TECHNICAL MEMORANDUM

No : 0089a

**SUBJECT:** Replacing S.E.L motor with E.G.O Motor on GP cabinets

Connecting wires E.G.O motor (GP1000)

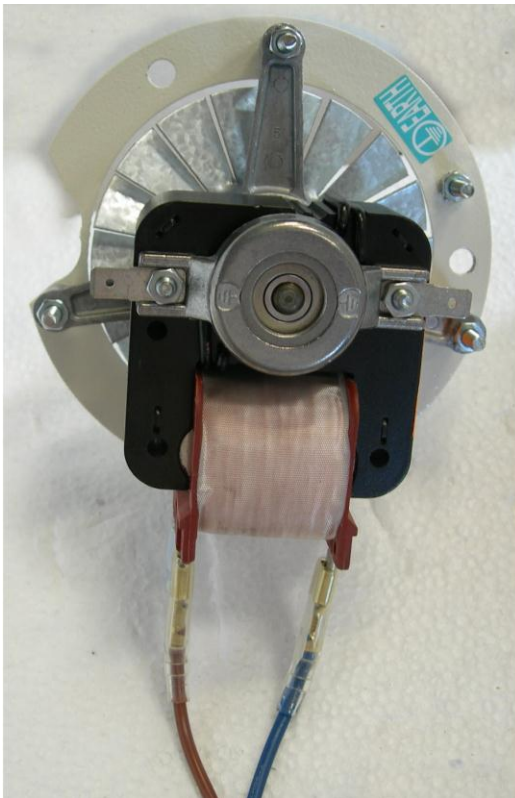
The S.E.L motor (GP1010/2010) is no longer available for the GP range of cabinets, it has been replaced by a new E.G.O motor (GP1000). The E.G.O motor and fan blade are very similar to the original. When replacing a S.E.L motor in the field a small kit is required, this will be automatically supplied whenever a GP1000/GP1010/2010 motor is ordered as a spare part. The kit consists of the following items:

1. GP1000 E.G.O motor complete with rotor which has been prewired with blue and brown motor wires of the same length (400mm) as the original motor. The motor adaptor ring has been modified to have a labelled earth stud fitted so that the original earth wire on the cabinet can be used with the replacement motor. Please ENSURE that the earth wire is connected to this terminal.
2. A copy of THIS techmemo.
